MODIFICATION REQUEST:

***Residential community title subdivision
and construction of 31 dwellings, at
1206D Pacific Highway and 36
Woodhouse Road, Moonee Beach
MP08_0003 MOD 1***

Director-General's
Environmental Assessment Report
Section 75W of the
Environmental Planning and Assessment Act 1979

September 2013

Figure 4: Proposed Modified Layout

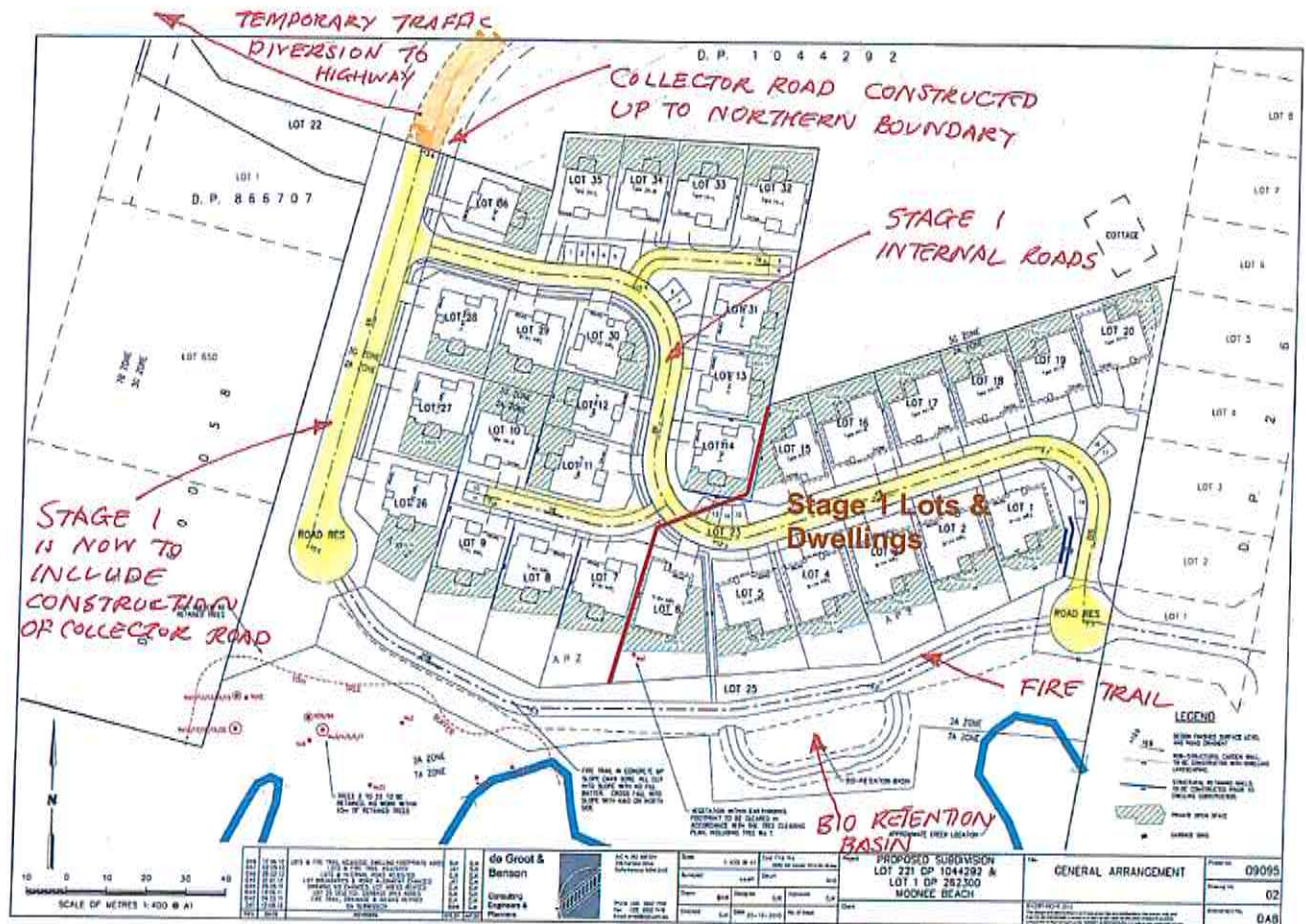
- an amended subdivision layout, including removal of an internal vehicular turning area and associated amendments to lot layouts, but with no changes to the total number of lots,

The proponent has revised and refined the subdivision layout arising from the earlier construction of the local collector road at Moonee and the ability to proceed with the full extent of the internal road linking to the collector road. The main feature of the amended layout is the deletion of the internal turning circle, which was to terminate at the end of the stage 1 section of the internal road.

This turning area is no longer required, as the construction of the full extent of the internal road will allow for vehicles to drive through the site without the need to turn back to Woodhouse Road. The department has no 'in principle' objection to removal of this internal turning area. This is also subject to the construction of the full extent of the internal roadway and the road being linked to the collector road, as discussed in section 5.1.

Figure 8: Comparison of approved and amended subdivision and lot layout

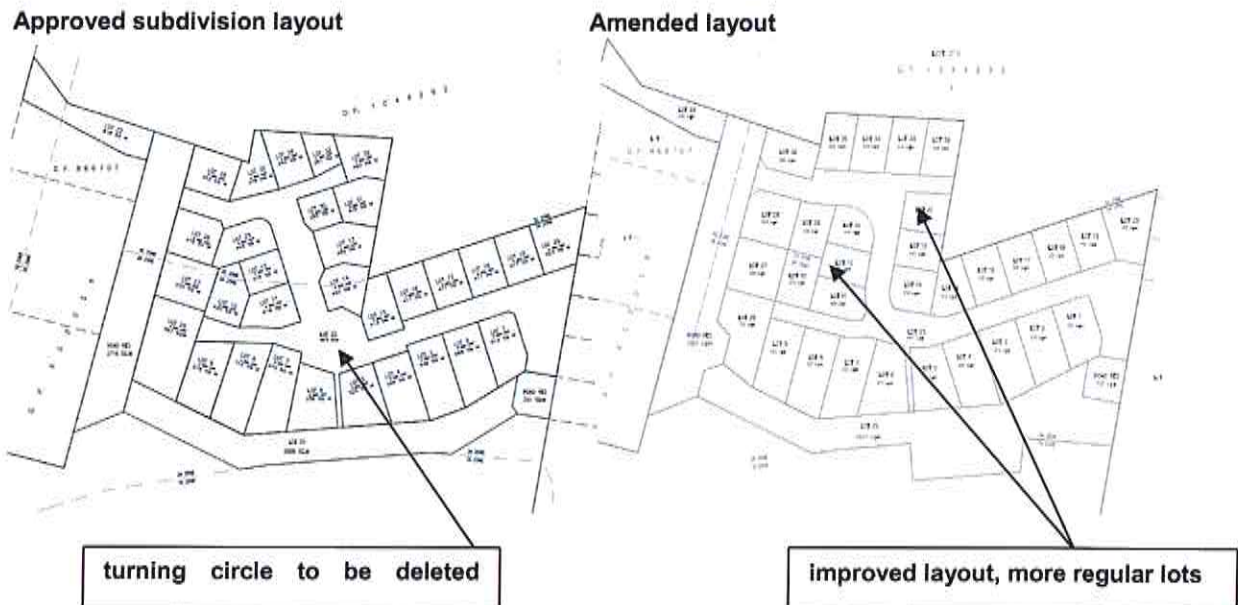
The deletion of the internal turning area has allowed the proponent to redesign the residential lots, and provide more regular lots boundaries, refer to Figure 8. The number of lots remains the same and the range of lot sizes will be consistent between the approved and modified plans.

Figure 9: Interim fire trail – stage 1

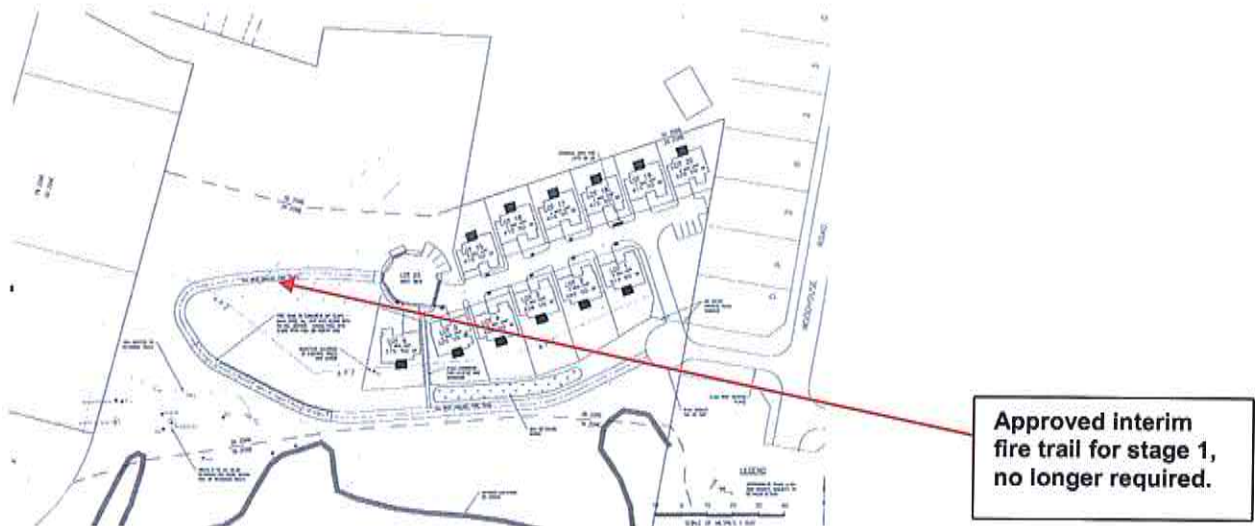
A fire trail is to be provided along the southern boundaries of the residential lots, and located within the community title lot 25. The project approval provided for an interim fire trail for stage 1 (refer to Figure 9). This interim bushfire access arrangement is no longer required as the full extent of the approved fire trail can now be constructed from Woodhouse Road at the east of the subdivision through to the collector road at the west (refer to Figure 4).

Figure 10: Relocation of bio-retention basin

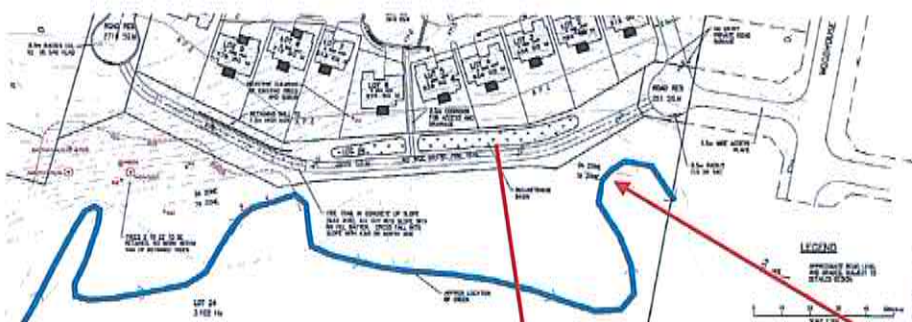
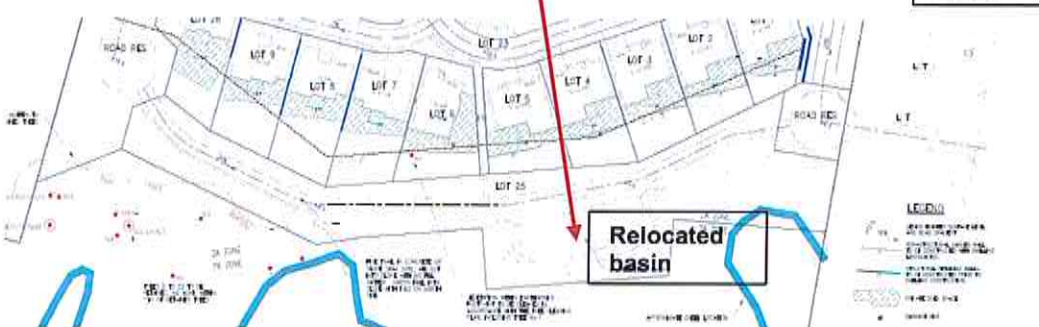
A bio-retention basin has been approved on the southern perimeter of the residential lots immediately to the north of the approved fire trail in stage 1, and within the section of the site zoned 2A. This basin is required as part of measures to control the quality and volumes of stormwater runoff from the subdivision. As part of the amended subdivision layout, the basin has been redesigned and has been relocated approximately 20m to the south. This has relocated the basin from an area north of the fire trail to an area south of the fire trail, where it is now largely within the part of the site zoned 7A Environmental Protection (refer to Figure 10).

The proponent has advised that has been relocated at council's request, following further site inspections by council's environmental officers prior to bulk earthworks and civil works. The revised location allows for the fire trail at each end of the basin to be located further from the adjacent creek to the south. Earthworks for the basin have already been undertaken with council approval with the basin being used as a part of sediment control measures during construction of the subdivision. This has therefore allowed for the fire trail to be shifted to the north, further away from the creekline.

No environmental impacts are expected from the revised location of the bio-retention basin. While it is now within the parts of the site zoned 7A environmental protection, it has been located within existing cleared and grassed areas, requiring no removal of trees. The revised location of the bio-retention basin has been taken into account within the Vegetation Management Plan (VMP), which was approved by council under condition B1 of the project approval, prior to the release of the construction certificate for bulk earthworks (refer to Figure 11 for an extract from the VMP showing the basin).

Figure 12: Proposed changes to the boundary between lot 24 and lot 25

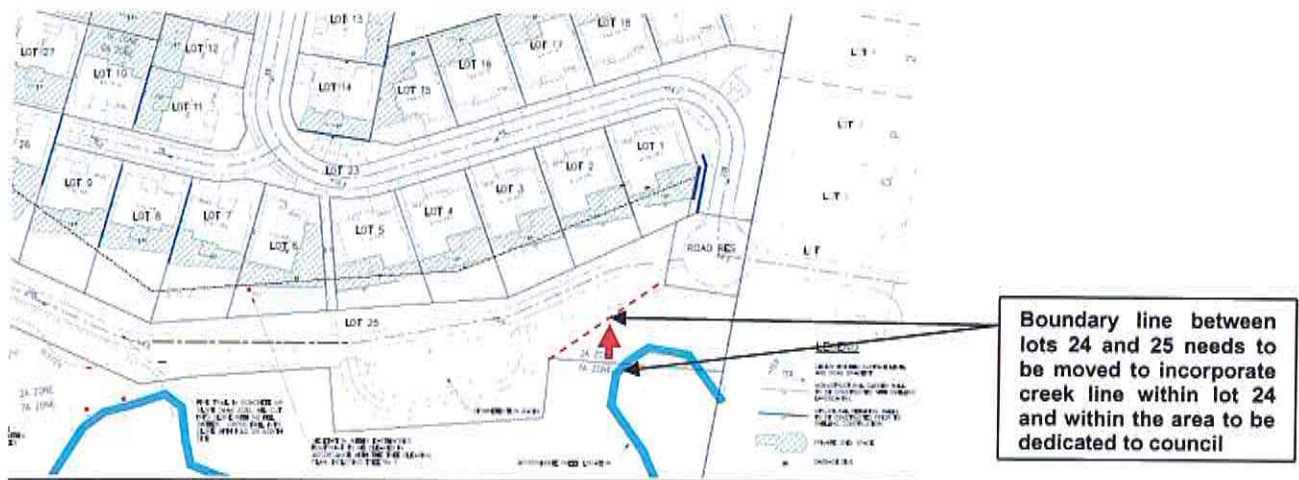
There are also boundary changes and an increase in the size of the community title lot (lot 25) containing the fire trail and bio-retention basin, due to the relocation of the basin. The lot will be increased from 2899sqm to 4441sqm to encompass the relocated basin. There are some unintended boundary changes to lot 25 which will need to be further amended to ensure that the creek line remains within lot 24, which is to be dedicated to council, as was intended in the original project approval (refer to Figure 12). This amendment is reflected in proposed modifications to condition A5.

Figure 13: Bulk earthworks and benched pads

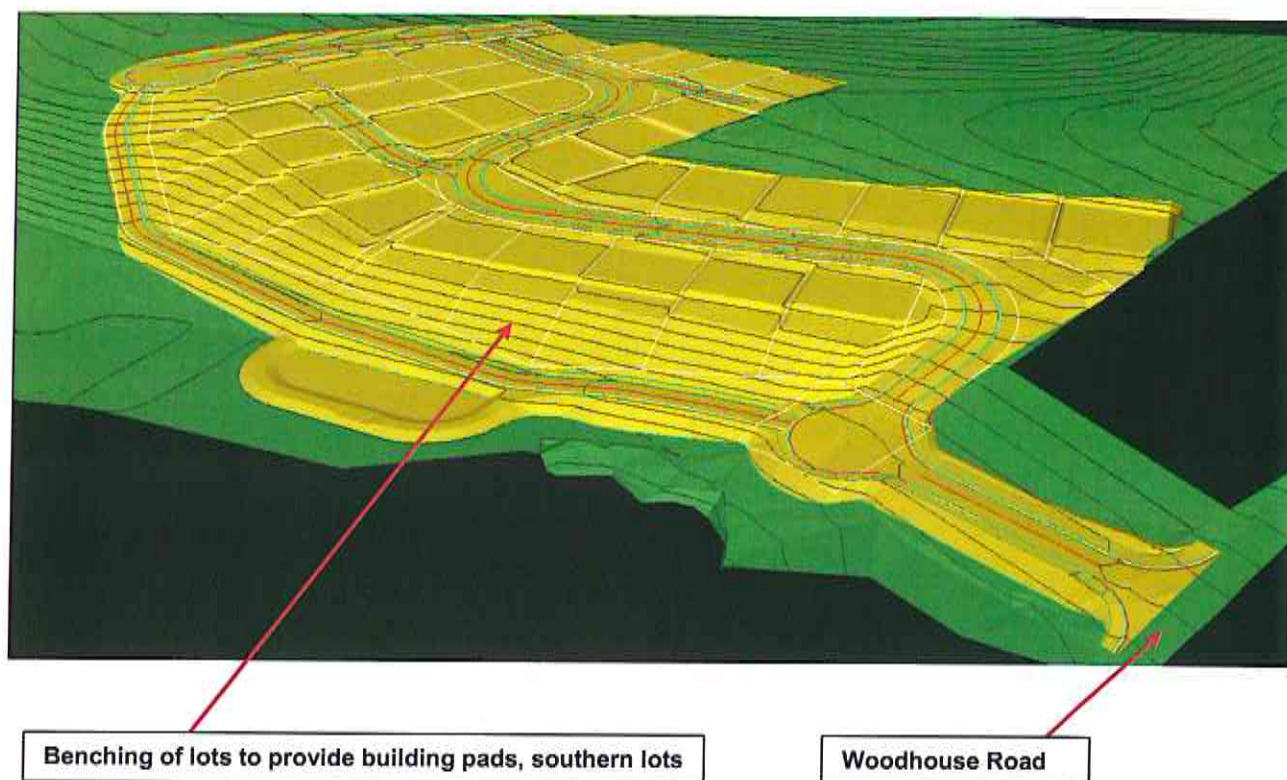
The modified project provides for more significant levels changes across the site with benching to provide level building pads and private open space areas for each of the residential lots, particularly for the lots along the southern side of the site. This is graphically represented in Figure 13.

The southern lots, where there have been the greatest changes in the finished levels, slope down to the fire trail along the rear boundary of the lots and these lots face down towards the areas of the site to be revegetated and dedicated to council as a public reserve. While the department would generally seek to limit the extent of cut and fill, in the circumstances of this case, removal of site earthworks and re-establishment of previously approved levels is not considered warranted as no significant impacts are expected from the new levels that have been approved through the construction certificate and already established on the site. Despite the changes in levels there are expected to be limited environmental and amenity impacts.
